Interactive comment on “Tsunami run-up estimation based on a hybrid numerical flume and a parameterization of real topobathymetric profiles” by Íñigo Aniel-Quiroga et al.

Íñigo Aniel-Quiroga et al.

Anonymous Referee #2 Received and published: 29 January 2018 General comments: This paper presents a method for quickly assessing tsunami runup for different tsunami wave shapes and bathymetries. The method is built on a hybrid approach, where the Non-Linear Shallow water model COMCOT is used for the deep-water propagation and a RANS models is used for the near shore processes. The results from this hybrid model, then enters an interpolation model, which can be used to assess run-up. The approach is novel and innovative, and I especially like adding a fast interpolation model. I have however, a few major concerns. The actual implementation of the hy-

Fig. 1.

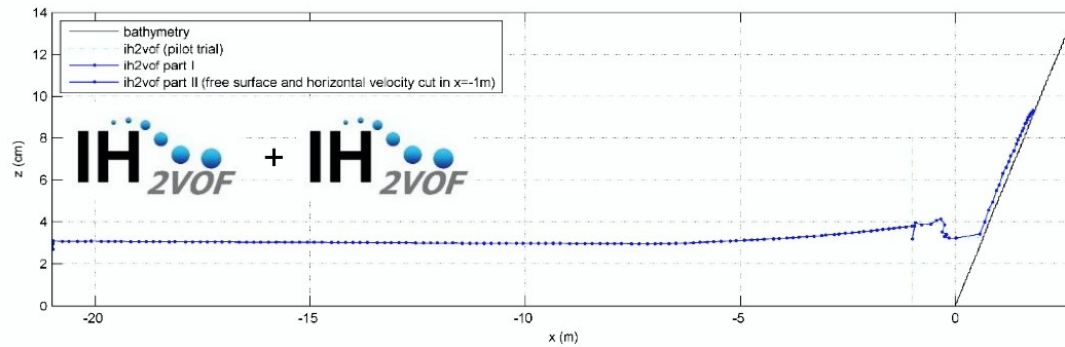
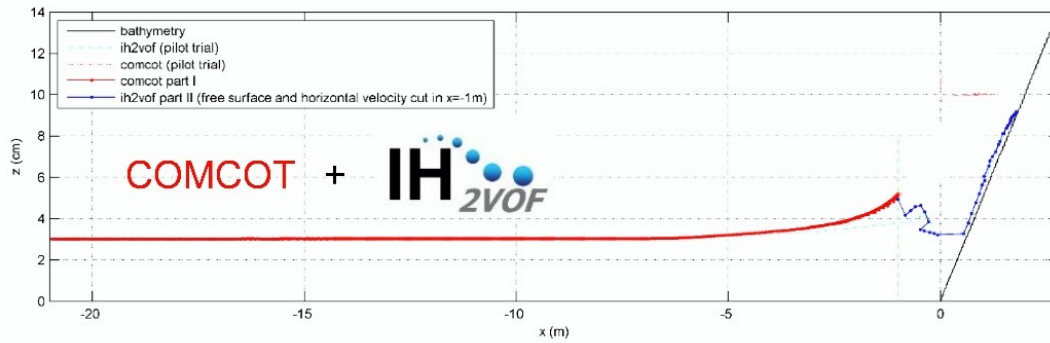
e) One of the advantages of the hybrid model is that the RANS model can handle processes that the simpler COMCOT model cannot. One of such processes is the wave splitting into an undular bore, which can happen when the wave travels long in shallow water and this has been witnessed in many real life tsunamis. To be able to capture this effect x_{cut} needs to be positioned sufficiently off shore. How is this ensured?

REPLY: Due to the exposed characteristics of the model it is not possible to extend the RANS model grid seawards more than what this limitation allows. Nevertheless, to avoid loss of processes on coupling, several coupling tests were performed. These tests were conducted reproducing the flume on scale, so a target simulation was performed using only the IH2VOF model. Lately, simulations of coupling between IH2VOF + IH2VOF and COMCOT + IH2VOF were performed and compared to single IH2VOF simulations. In both cases, IH2VOF cases coupling methods reproduce evolution of single IH2VOF simulations adequately. In the attached figure one of the conducted

tests is given. In this figure, it can be observed that, when the last part of the flume is calculated by means of IH2VOF model, the comparison between the different combinations of models is accurate in terms of run-up.

AS a consequence, the part of the processes that are not covered by LSWE model is incorporated in the last part of the flume, where the RANS model works.

Fig. 2.

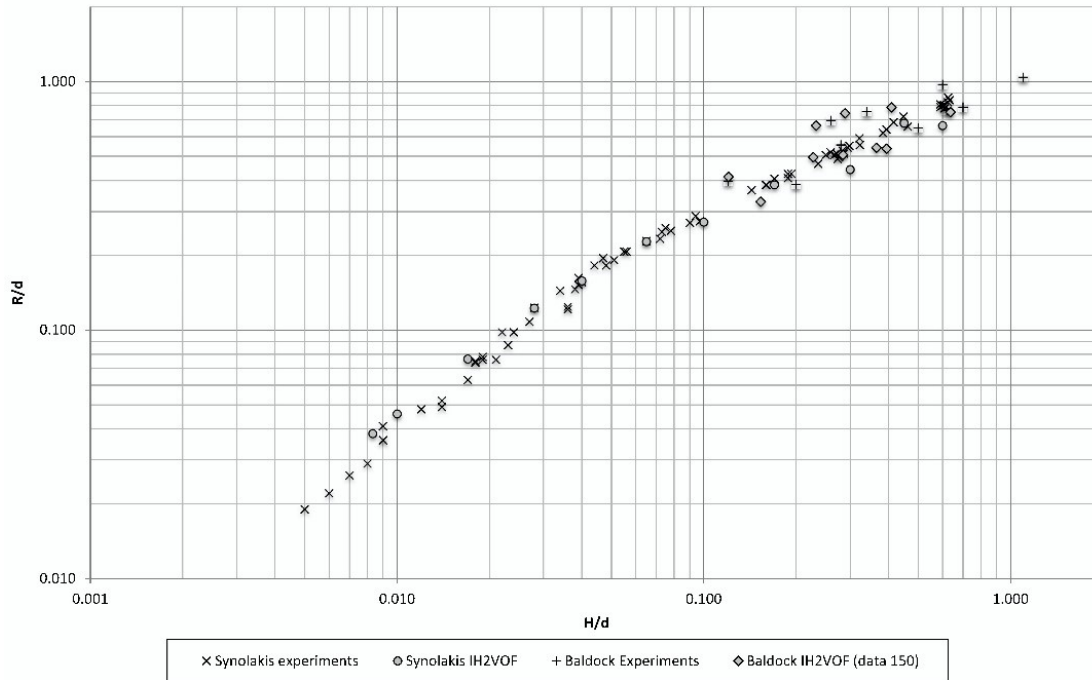
2) The first validation case is performed by comparing the interpolation model to the hybrid model. This is an important and satisfying validation case, but I am lacking validation of the actual hybrid model. How will the model perform using the approach outlined in the paper e.g. in cases with both breaking and non-breaking waves running up a constant slope.

REPLY: Both, COMCOT and IH2VOF models are models that have already been successfully validated in the past. The validation of the numerical flume and the coupling of the models was made by comparing its results with those conducted by Synolakis (1987) and Baldock (2009). The scenarios of these experiments were calculated using

COMCOT, IH2VOF, COMCOT+IH2VOF (the complete numerical flume) and the results were compared to the results of the physical experiments. The attached figure shows the run-up obtained in this comparison and how the results of both series of experiments fit adequately with the numerical flume results. This validation allowed us to continue with the database elaboration, and the database itself was then validated by comparing the results with both numerical models and field work data.

IH2VOF model is, in the hybrid model, the responsible of incorporating non-linearities and breaking effects. In this sense, apart from the validation as part of the numerical flume, it has also been validated and applied in many studies e.g. The shown figure, together with an explanation of the validation has been added to the manuscript, at the end of section 2 (pages 13).
